## Product Change Notice (PCN)

**Subject:** Assembly materials change for R8C/L3x LFQFP 100pin package products

# Difference of specification (R8C/L3Ax LFQFP 100pin)

# Material change items

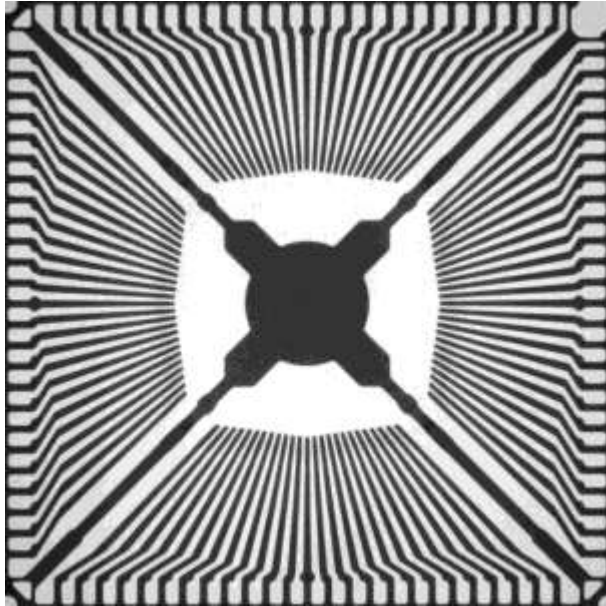
| Item       |          | Before change                     | After change                           |
|------------|----------|-----------------------------------|--|
| Mold resin | Material | Epoxy resin A *<br>(halogen-free) | Epoxy resin A or B *<br>(halogen-free) |

\* Although there are material changes, the combination after the change has a track record of mass production, and there is no change in reliability and characteristics.

# Lead frame shape

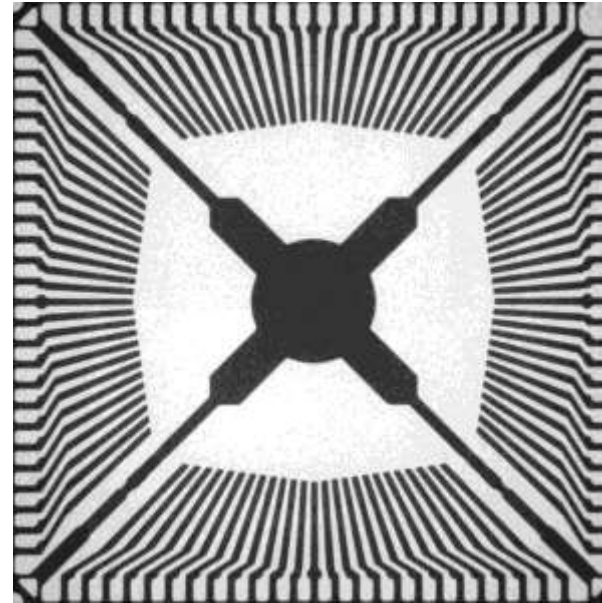
14×14mm 0.5mm pitch 100pin LFQFP lead frame

Consolidate into certified and proven lead frames.

Before change: “Frame A”

After change “Frame C”
